Subject: SQUG Advisory 2004-01: GERS Correction for General Electric IAC66K Relay

SQUG ADVISORY 2004-01: GERS Correction for General Electric IAC66K Relay

Impact of Additional Seismic Testing on GE IAC66K Protective Relay

Figure 1 IAC66K Relay Internal Configuration

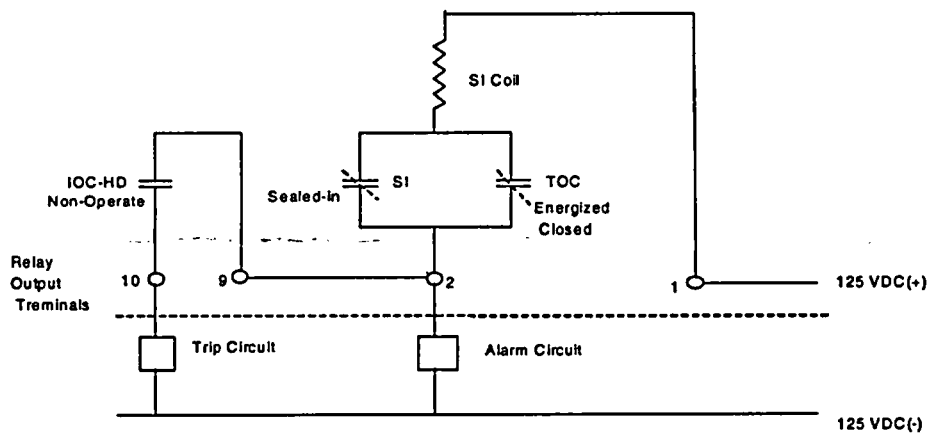
The IAC66K is actually three separate sub-component relays wired together to operate as a system. Each sub-component relay operates at different levels of input AC current to close its respective normally open contact. First, the time overcurrent (TOC) unit is a standard induction disk relay (designated as inverse, long time) that takes several seconds to operate. The TOC unit is set to begin timing operation at a low AC current setting. When this low current setting has been exceeded and the induction disk has finished its rotation, the TOC contact closes which energizes the coil of a target & seal-in (SI) relay, which closes an additional contact that is wired in parallel with the TOC contact. When the SI contact is closed, the SI relay coil is energized by its own contact, and the circuit is said to be sealed-in. The TOC contact can chatter or even open, but the SI contact remains closed. The output of the TOC/SI contact set is used as an alarm indication only. Next, a high dropout instantaneous overcurrent (IOC-HD) relay is set to operate at an intermediate current level. The IOC-HD output contact is wired in series with the TOC/SI contact set and connected with the plant DC control circuit for switchgear tripping. Thus, for the series contact pair to have an output, the contacts of *both* units must be closed. If the IOC-HD contact chatters and the TOC/SI contact set is open, then the DC circuit is still open and the chatter cannot affect the switchgear trip circuit. Likewise, chatter of the TOC/SI contact set can only affect the switchgear trip circuit if the IOC-HD contact has simultaneous chatter. If the TOC/SI contact set is sealed-in, then IOC-HD contact chatter can cause spurious switchgear operation. Finally, a separate instantaneous overcurrent (IOC-N) relay is set to operate at a high current. The IOC-N contact is directly connected to the switchgear trip circuit, thus IOC-N contact chatter can directly cause spurious switchgear operation.

The consequences of the GERS typographical error for the IOC-HD subcomponent of the IAC66K will depend upon how the results were utilized in A-46 relay reviews. If the minimum value of 5 g indicated in the GERS report for the TOC/SI unit was used as the non-operate fragility of the relay, then there is no issue concerning the actual lower fragility of the IOC-HD unit being less than 5 g, since the output contacts of the pair of units are connected in series and the non-operate fragility of the series pair is 5 g. However, if the relay evaluation recognized the series contact pair and concluded that the relay fragility in the non-operate mode was governed by the highest fragility level, then the use of the 10 g value erroneously indicated for the IOC-HD would result in an incorrect non-operate fragility for the relay. In this case, the non-operate fragility of 7 g for the separate IOC-N unit would govern. For the operate mode, the 2 g value erroneously indicated for the IOC-HD unit would govern the operate relay fragility in all cases.

The test fragility level for a GE IAC66K relay was established in the Reference report (based on SQUG testing of a model 12IAC66K8A) and was inferred to be the GERS for the IAC66K protective relay model. Subsequent testing of a GE protective relay, model 12IAC66K58A, was conducted by the SQRSTS program with anomalous results. SQUG was contacted to review the SQRSTS test results to ascertain if a conflict with the GERS existed. After review of the SQRSTS data, SQUG recommended retest of the relay with an alternate test monitoring setup. Review of the overall test effort indicated that the observed results were not inconsistent with previous SQUG testing, but rather the behavior that should be expected for an intermediate (alarm) operate state. However, the review of the SQRSTS testing results and the expected operation characteristics of this relay did indicate that the test fragility values reported in the Reference report for the IAC66K subcomponent IOC-HD contact (designated as HDI in the EPRI report) have been interchanged for the non-operate and operate mode. The GERS level for the GE IAC66K relay should be corrected as follows:

IAC66K Sub-Component	Non-operate NO contact	Operate NO contact
	GERS	GERS
TOC/SI [SI/TOC]*	5	10
IOC-HD [HDI]*	10 2	2 10
IOC-N [STD]*	7	7

Figure 1. Alternate Output Monitoring Circuit

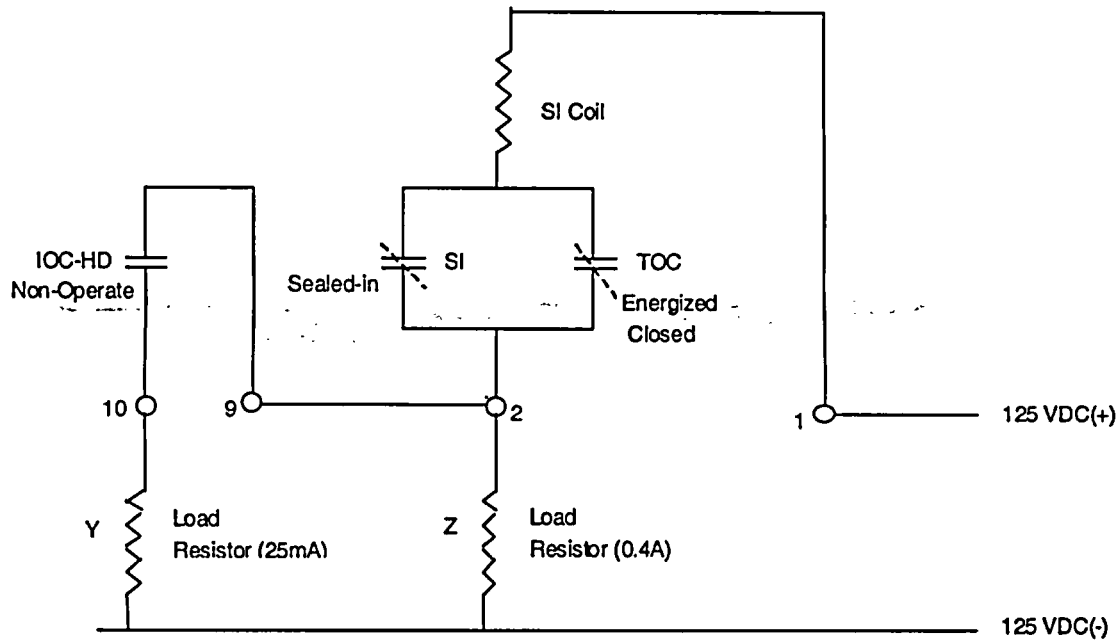
The procedure that was used in the SQUG relay testing program (Reference 2), in the case of protective relays, was to test each relay sub-component as a separate device. For the DC output circuit, the contacts of each relay were separately monitored for chatter. The alternate output monitoring circuit, shown in Figure 1, was used in the SQRSTS testing of the IAC66K. In this wiring setup, the TOC/SI (terminals 1-2) and IOC-HD (terminals 2-10) contacts are wired in series to reflect how the relay is actually used rather than monitoring each contact set individually (which requires a change of internal relay wiring).

For the operate mode tests, the SQRSTS testing was conducted with the relay input at 200% pull-in current of the TOC/SI, but this input current level was only approximately 75% of the pull-in of the IOC-HD, thus the IOC-HD was actually in the non-operate mode. Thus, the operate mode testing was actually conducted in the alarm state with the TOC/SI operated (and sealed-in), and with the IOC-HD in a non-operate mode. This is the contact state indicated in Figure 1. As can be noted in Figure 1, the IOC-HD is free to chatter which led to the anomalous results observed during the testing. The contact monitor indicated chatter on both the TOC/SI and IOC-HD contacts for low test input levels. Since the TOC/SI unit had operated and sealed-in, this behavior indicates that IOC-HD was chattering at a very low motion level. The apparent chatter noted on the TOC/SI is not actually a chatter, but instead a current fluctuation due to the IOC-HD loop of the monitoring circuit going in and out of the circuit when the IOC-HD contact chatters (see Figure 1). Thus, the test results are actually for the IOC-HD contact in the non-operate mode.

Based on the data available, it is judged that the fragility levels of the IOC-HD sub-component of the IAC66K is slightly greater than 2 g (4-16 Hz range) in the non-operate mode. Based on SQUG testing experience, relays designated as "high dropout" units (i.e., drop out with only a small decrease in voltage or current) tend to have low ruggedness for the normally open contact. Therefore, a conservative value of 2 g is used. It is judged that the fragility levels of the TOC/SI units are greater than 5 g (4-16 Hz range) in the non-operate mode. Based on a review of the available test data, it is apparent that the non-operate and operate GERS levels for the IOC-HD [HDI] given in Reference 1 should be interchanged to indicate that non-operate fragility level is 2 g and that the operate level is 10 g.
